SERVICE BULLETIN

N° 139-362

REV. : A - August 3, 2022

ATA 76 - ENGINE CONTROL MECHANICAL BACK-UP

Figure 1

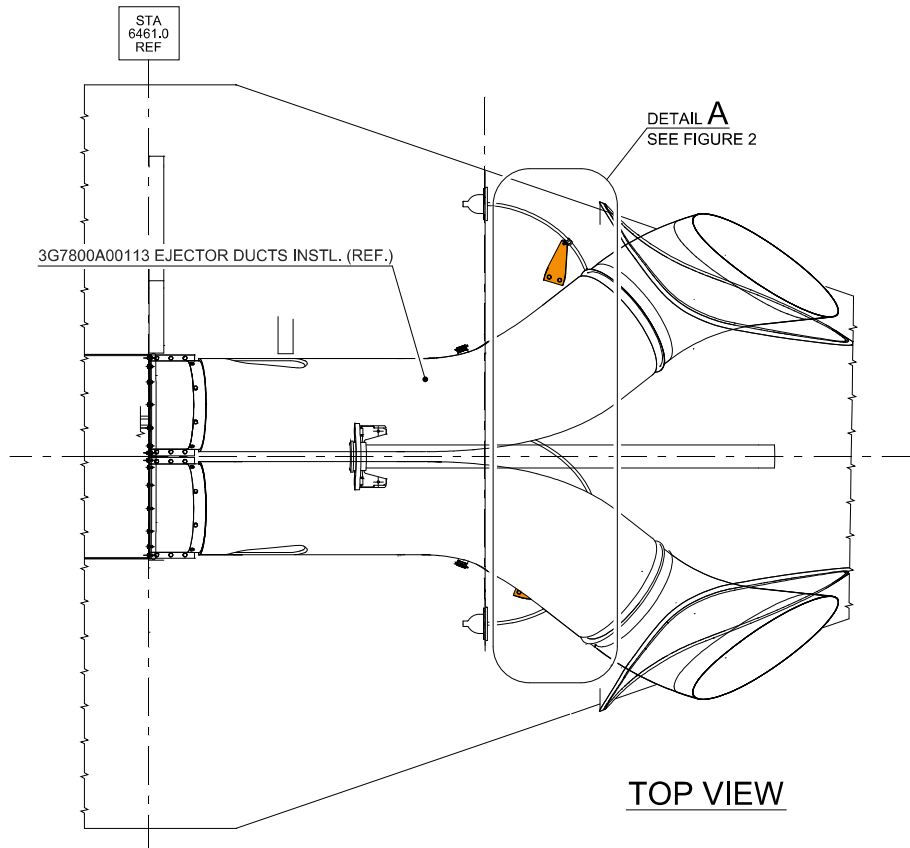
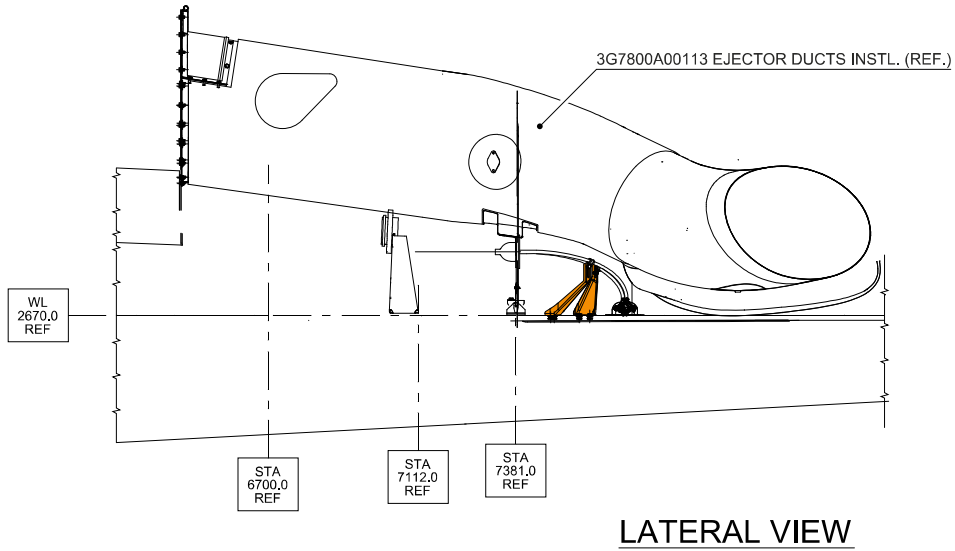
1. In accordance with AMP DM 39-A-00-20-00-00A-120A-A, prepare the helicopter on ground for a safe maintenance. Disconnect the battery, all electrical power sources and/or the external power supply.
2. In accordance with AMP DM 39-A-06-41-00-00A-010A-A and with reference to Figures 1 and 2, remove all external panels, internal panels and internal liners as required to gain access to the area affected by the installation and perform the engine control mechanical backup LH/RH P/N 3G7606P00311 as described in the following procedure:
 - 2.1 With reference to Figure 2 Detail A, temporarily locate the two supports P/N 3G7610A00551 on the structure. Countermark position of n°4 insert holes in the panel.

2. In accordance with AMP DM 39-A-06-41-00-00A-010A-A and with reference to Figures 1 and 2, remove all external panels, internal panels and internal liners as required to gain access to the area affected by the installation and perform the engine control mechanical backup RH P/N 3G7606P00311 as described in the following procedure:

Figure 2

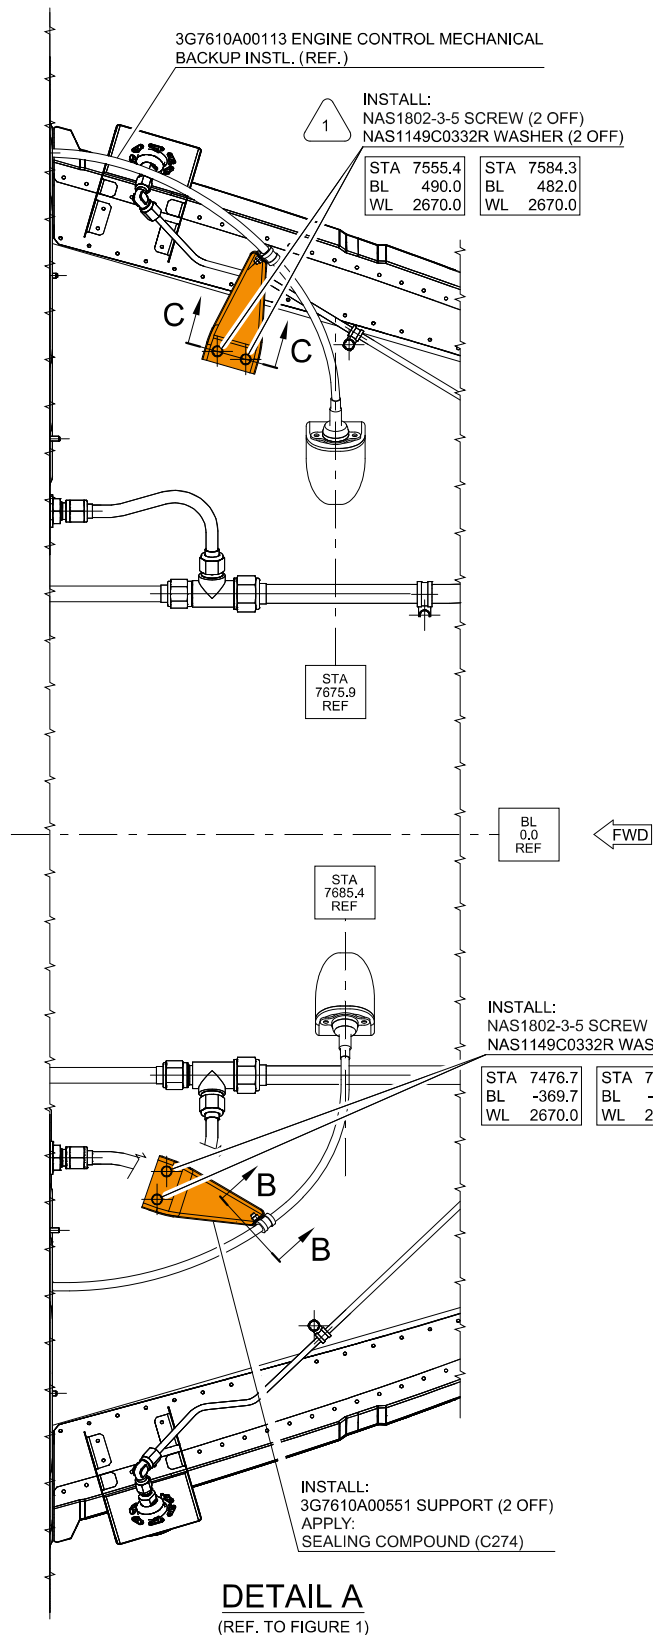
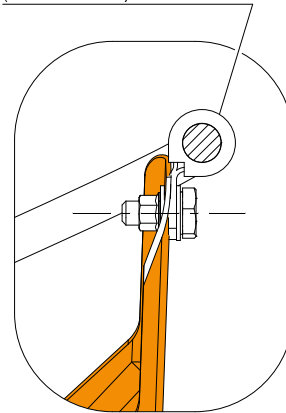
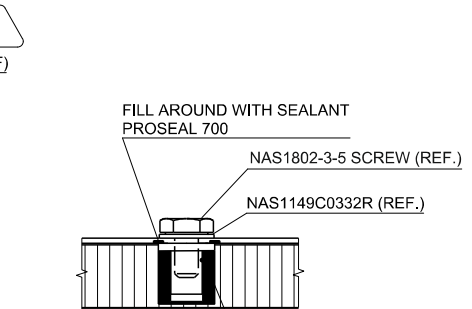
- Update of the Accomplishment Instructions;
- Update of Figure 2;
- Update of Figure 4.

- 2.1 In accordance with CSRP DM CSRP-A-51-42-00-00A-720A-D and with reference to Figure 2 Section C-C, drill n°4 \varnothing 17.42 ÷ 17.55 holes through skin and honeycomb and up to a depth of 13.
- 2.2 With reference to Figure 2 Section C-C, install n°4 inserts P/N NAS1836-3-13 by means of adhesive EA934NA AERO (C397).

- 2.3 With reference to Figure 2 Detail A, install n°2 supports P/N 3G7610A00551 by means of n°4 screws P/N NAS1802-3-5 and n°4 washers P/N NAS1149C0332R. In accordance with AMP DM 39-A-20-00-00-00A-711A-A, tighten the four screws to the standard torque values.

- 2.4 In accordance with AMP DM 39-A-20-00-00-00A-711A-A and with reference to Figure 2 Section B-B, install n°2 clamps P/N AS21919WDG06 by means of n°2 bolts P/N AN3C3A, n°4 washers P/N NAS1149C0332R and n°2 nuts P/N MS21043-3; route the ECL cable within the clamp and tighten the two nuts to the standard torque values.

- 2.1 With reference to Figure 2 Detail A, temporarily locate the support P/N 3G7610A00551 on the left side of the structure. Countermark position of n°2 insert holes in the panel.

- 2.2 In accordance with CSRP DM CSRP-A-51-42-00-00A-720A-D and with reference to Figure 2 Section C-C, drill n°2 $\varnothing 17.42 \div 17.55$ holes through skin and honeycomb and up to a depth of 13.

- 2.3 With reference to Figure 2 Section C-C, install n°2 inserts P/N NAS1836-3-13 by means of adhesive EA934NA AERO (C397).

- 2.4 With reference to Figure 2 Detail A, install support P/N 3G7610A00551 by means of n°2 screws P/N NAS1802-3-5 and n°2 washers P/N NAS1149C0332R. In accordance with AMP DM 39-A-20-00-00-00A-711A-A, tighten the two screws to the standard torque values.

- 2.5 With reference to Figure 2 Section B-B and in accordance with AMP DM 39-A-20-00-00-00A-711A-A, install the clamp P/N AS21919WDG06 by means of n°1 bolt P/N AN3C3A, n°1 washer P/N NAS1149C0332R and n°1 nut P/N MS21043-3; route the ECL cable within the clamp and tighten the nut to the standard torque values.

1 INSTALL:
AN3C3A BOLT
NAS1149C0332R WASHER (2 OFF)
AS21919WDG06 CLAMP
MS21043-3 NUT
(TYP. 2 PLACES)

DRILL:
HOLE Ø 11.48 - 11.61
INSTALL:
NAS1836-3-13 INSERT
IN ACCORDANCE WITH ASRP DM 39-A-51-42-01-00A-720A-A
APPLY:
ADHESIVE EA934NA AERO (C397)

Figure 3

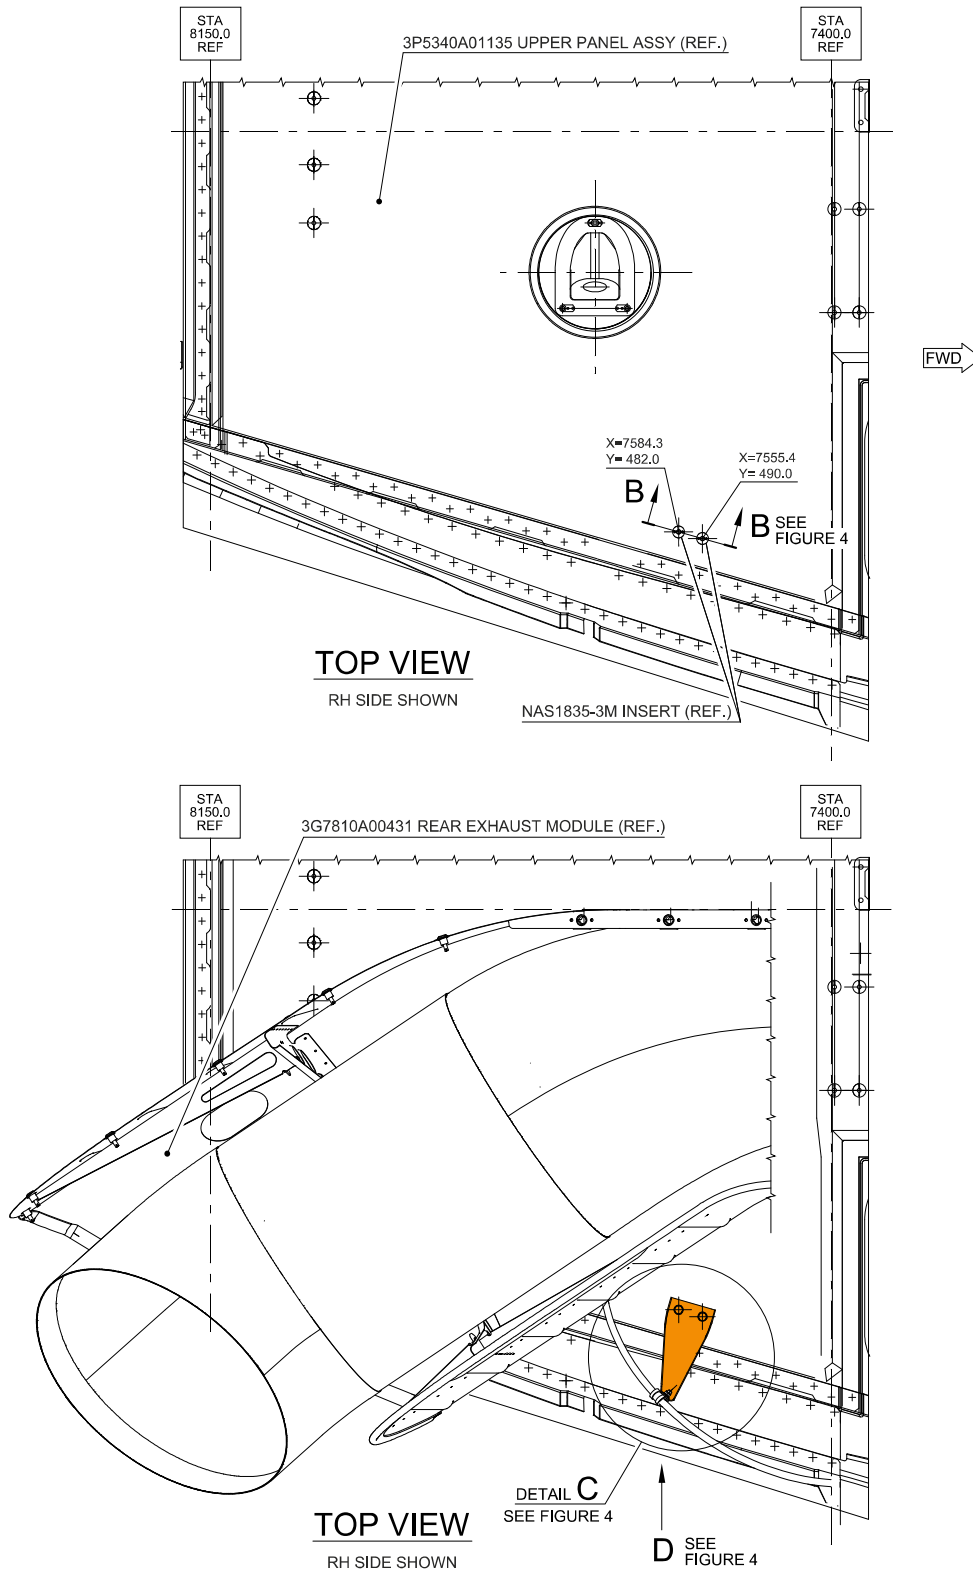
1. In accordance with AMP DM 39-A-00-20-00-00A-120A-A, prepare the helicopter on ground for a safe maintenance. Disconnect the battery, all electrical power sources and/or the external power supply.
2. In accordance with AMP DM 39-A-06-41-00-00A-010A-A and with reference to Figures 3 and 4, remove all external panels, internal panels and internal liners as required to gain access to the area affected by the installation and perform the engine control mechanical backup RH side retro modification RH P/N 3G7606P00211 as described in the following procedure:
 - 2.1 With reference to Figure 4 Detail C, temporarily locate the support P/N 3G7610A00551 on the structure. Countermark position of n°2 insert holes in the panel.

Figure 4

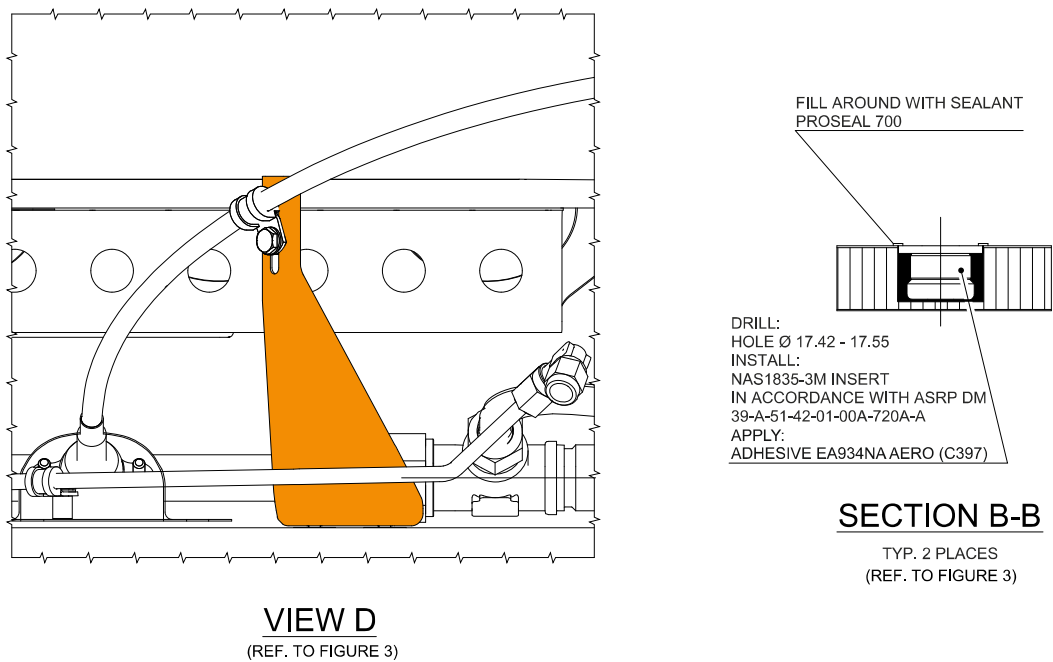
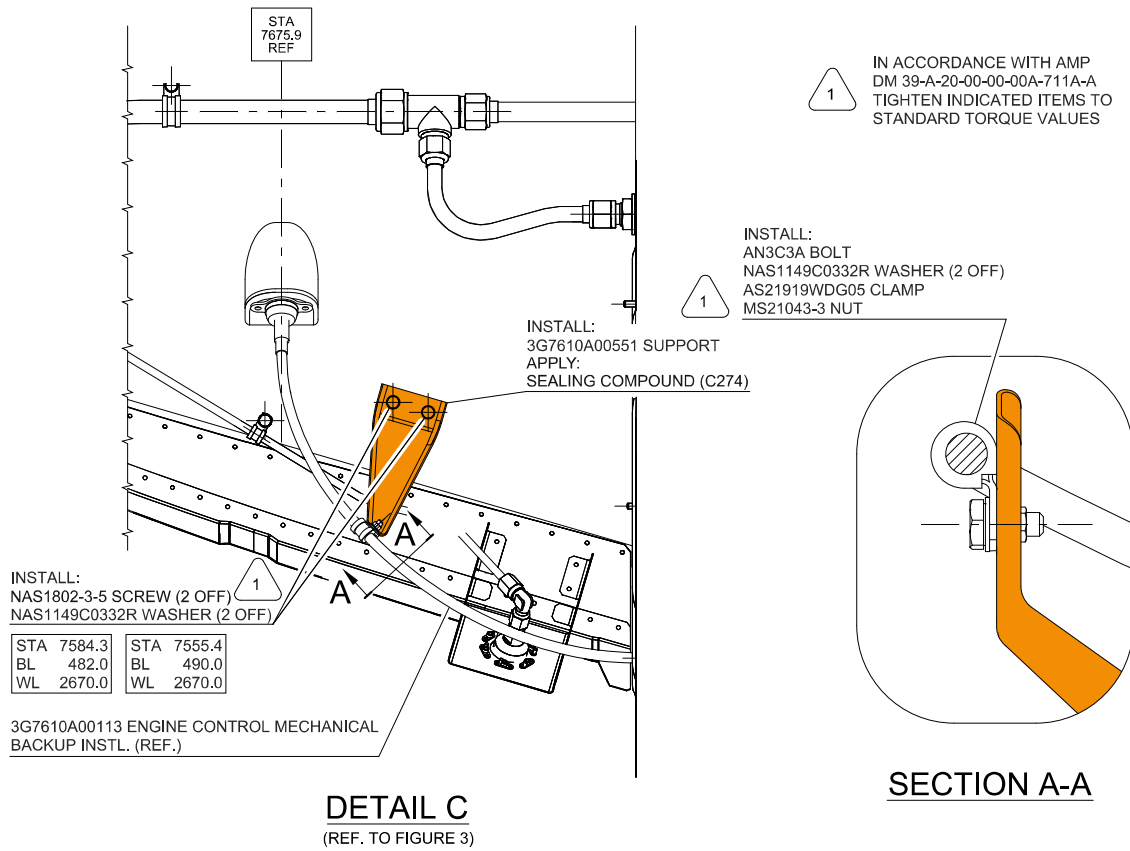
- 2.2 In accordance with CSRP DM CSRP-A-51-42-00-00A-720A-D and with reference to Figure 4 Section C-C, drill n°4 \varnothing 17.42 \div 17.55 holes through skin and honeycomb and up to a depth of 13.
- 2.3 With reference to Figure 2 Section B-B, install n°2 inserts P/N NAS1835-3M by means of adhesive EA934NA AERO (C397).

- 2.4 With reference to Figure 4 Detail C, install the support P/N 3G7610A00551 by means of n°2 screws P/N NAS1802-3-5 and n°2 washers P/N NAS1149C0332R. In accordance with AMP DM 39-A-20-00-00-00A-711A-A, tighten the two screws to the standard torque values.
- 2.5 In accordance with AMP DM 39-A-20-00-00-00A-711A-A and with reference to Figure 4 Section A-A, install the clamp P/N AS21919WDG05 by means of the bolt P/N AN3C3A, n°2 washers P/N NAS1149C0332R and the nut P/N MS21043-3; route the ECL cable within the clamp and tighten the two nuts to the standard torque values.
3. In accordance with AMP DM 39-A-06-41-00-00A-010A-A re-install all external panels, internal panels and internal liners previously removed.
4. In accordance with weight and balance changes, update the Chart A (see Rotorcraft Flight
